SERVICE BULLETIN

_{N°} 139-577

ATA 53 - LOWER INSPECTION COVER INSTALLATION

Revision A is issued in order to introduce the instructions to avoid possible interferences with the previous repairs.

Figure 1

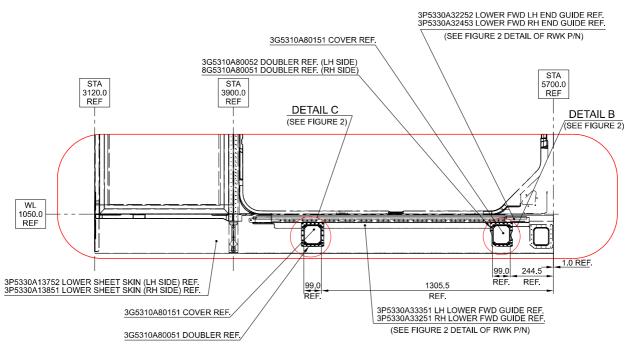
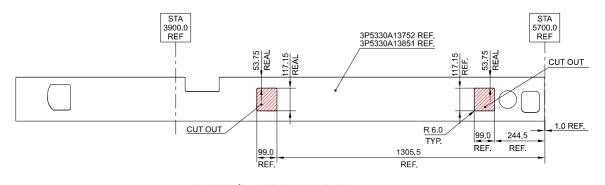
- 2.2 With reference to Figure 1 Detail A, remove the existing fasteners that attach the LH lower FWD guide P/N 3P5330A33351 to the LH lower sheet skin P/N 3P5330A13752. Keep them for later reuse.
- 2.3 With reference to Figure 1 Detail A, remove the LH lower FWD guide P/N 3P5330A33351 and the lower FWD LH end guide P/N 3P5330A32252 from the helicopter. Keep hardware for later reuse.

- 2.4 With reference to Figure 2 Detail B, remove the reinforcement P/N 3P5330A32551.
- 2.5 With reference to Figure 1 Detail of RWK P/N, perform n°2 cut-outs on the lower sheet skin LH P/N 3P5330A13752.
- 2.6 With reference to Figure 2 Detail of RWK P/N, perform n°2 cut-outs on the LH lower FWD guide P/N 3P5330A33351.
- 2.7 With reference to Figure 2 Detail of RWK P/N, perform the indicated cut-out on the FWD LH end guide P/N 3P5330A32252.

- 2.9 With reference to Figure 1 Detail A and Figure 2 Detail B, install n°4 anchor nuts P/N MS21073L08 on the doubler P/N 3G5310A80052 by means of n°8 rivets P/N MS20426AD3-4.

- 2.10 With reference to Figure 1 Detail A and Figure 2 Detail B, temporarily locate the doubler P/N 3G5310A80052 on the LH lower sheet skin P/N 3P5330A13752, countermark and drill n°17 rivet holes thru the skin.

- 2.11 With reference to Figure 1 Detail A and Figure 2 Detail B, install the doubler P/N 3G5310A80052 on the LH lower sheet skin P/N 3P5330A13752 by means of n°16 rivets P/N MS20470AD4-4 and the rivet P/N MS20426AD4-4.

- 2.13 With reference to Figure 1 Detail A and Figure 2 Detail B, install the cover P/N 3G5310A80151 on the doubler P/N 3G5310A80052 by means of n°4 screws P/N AN525-832R6.

- 2.16 With reference to Figure 1 Detail A and Figure 2 Detail C, temporarily locate the doubler P/N 3G5310A80051 on the LH lower sheet skin P/N 3P5330A13752, countermark and drill n°22 rivet holes thru the skin.

- 2.17 With reference to Figure 1 Detail A and Figure 2 Detail C, install the doubler P/N 3G5310A80051 on the LH lower sheet skin P/N 3P5330A13752 by means of n°22 rivets P/N MS20470AD4-4.

- 2.19 With reference to Figure 1 Detail A and Figure 2 Detail C, install the cover P/N 3G5310A80151 on the doubler P/N 3G5310A80051 by means of n°4 screws P/N AN525-832R6.

Figure 2

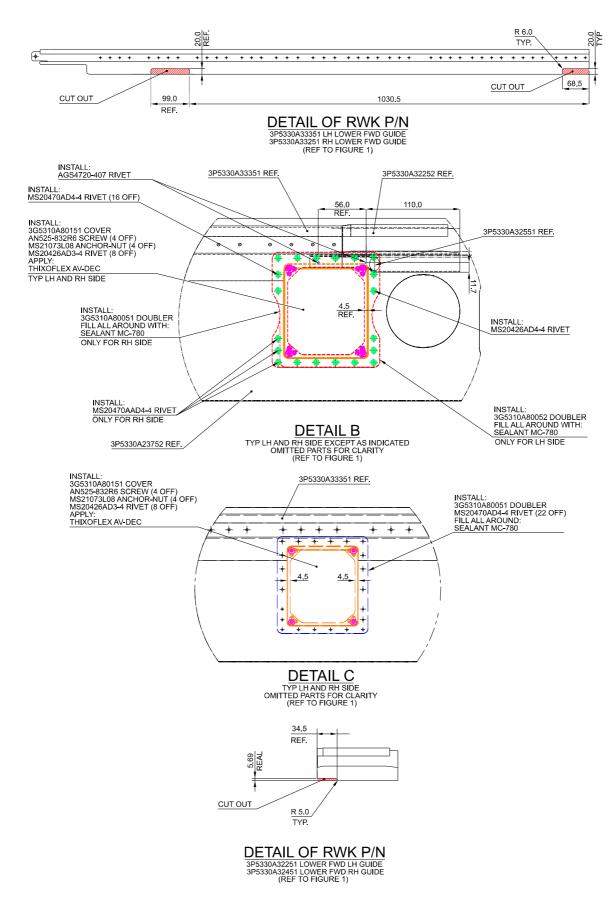
- 2.21 With reference to Figure 2 Detail B, temporarily locate the reinforcement P/N 3P5330A32551 in its position on the LH lower sheet skin P/N 3P5330A13752 and drill n°2 rivet holes in accordance with the dimensioning shown.
- 2.22 With reference to Figure 2 Detail B, install the reinforcement P/N 3P5330A32551 on the LH lower sheet skin P/N 3P5330A13752 by means of n°2 rivets P/N AGS4720-407.
- 2.23 With reference to Figure 1, install the LH lower FWD guide P/N 3P5330A33351 on the LH lower sheet skin P/N 3P5330A13752 by means of retained hardware.
- 2.24 With reference to Figure 1, install the lower FWD LH end guide P/N 3P5330A32252 on the LH lower sheet skin P/N 3P5330A13752 by means of retained hardware.
- 2.25 In accordance with AMP DM 39-A-52-12-01-00A-720A-A, install the cabin door LH on the helicopter.

- 2.29 With reference to Figure 2 Detail B, remove the reinforcement P/N 3P5330A32551.
- 2.30 With reference to Figure 1 and 2, repeat steps from 2.5 thru 2.8 for the RH side to rework the RH lower sheet skin P/N 3P5330A13851, the RH lower FWD guide P/N 3P5330A33251, the FWD RH end guide P/N 3P5330A32452 and the reinforcement P/N 3P5330A32551.

- 2.38 With reference to Figure 2 Detail B, temporarily locate the reinforcement P/N 3P5330A32551 in its position on the RH lower sheet skin P/N 3P5330A13851 and drill n°2 rivet holes in accordance with the dimensioning shown.

- 2.39 With reference to Figure 2 Detail B, install the reinforcement P/N 3P5330A32551 on the RH lower sheet skin P/N 3P5330A13851 by means of n°2 rivets P/N AGS4720-407.

Figure 3

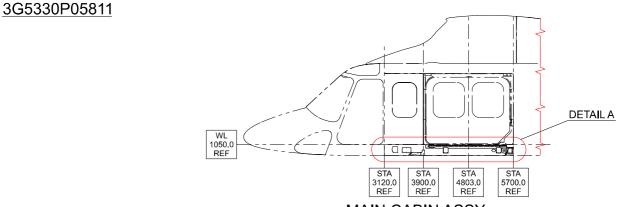
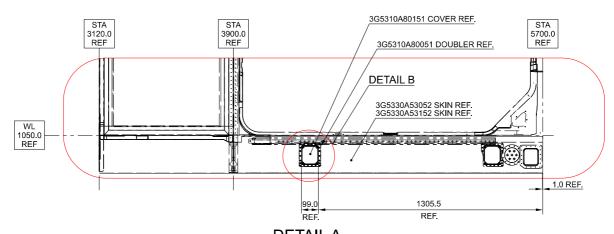
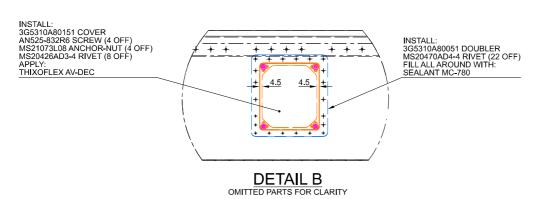
- 2.1 With reference to Figure 3 Detail of RWK P/N, perform n°2 cut-outs on the skin LH P/N 3G5330A53052.
 - 2.2 With reference to Figure 3 Detail A and Detail B, install n°4 anchor nuts P/N MS21073L08 on the doubler P/N 3G5310A80051 by means of n°8 rivets P/N MS20426AD3-4.

- 2.3 With reference to Figure 3 Detail A and Detail B, temporarily locate the doubler P/N 3G5310A80051 on the skin LH P/N 3G5330A53052, countermark and drill n° 22 rivet holes.

- 2.4 With reference to Figure 3 Detail A and Detail B, install the doubler P/N 3G5310A80051 on the skin LH P/N 3G5330A53052 by means of n°22 rivets P/N MS20470AD4-4.

- 2.5 With reference to Figure 3 Detail A and Detail B, fill all around the doubler P/N 3G5310A80051 by means of the Naftoseal MC-780 (C355).
 - 2.6 With reference to Figure 3 Detail A and Detail B, install the cover P/N 3G5310A80151 on the doubler P/N 3G5310A80051 by means of n°4 screws P/N AN525-832R6.

- 2.7 With reference to Figure 3 Detail A and Detail B, apply the sealant (C347) along the perimeter of the cover P/N 3G5310A80151.
 - 2.8 With reference to Figure 3 Detail of RWK P/N, repeat step 2.1 to rework the skin RH P/N 3G5330A53152.

- 2.9 With reference to Figure 3, repeat steps from 2.2 thru 2.8 to install the cover P/N 3G5310A80151 and the doubler P/N 3G5310A80051 on the RH side.
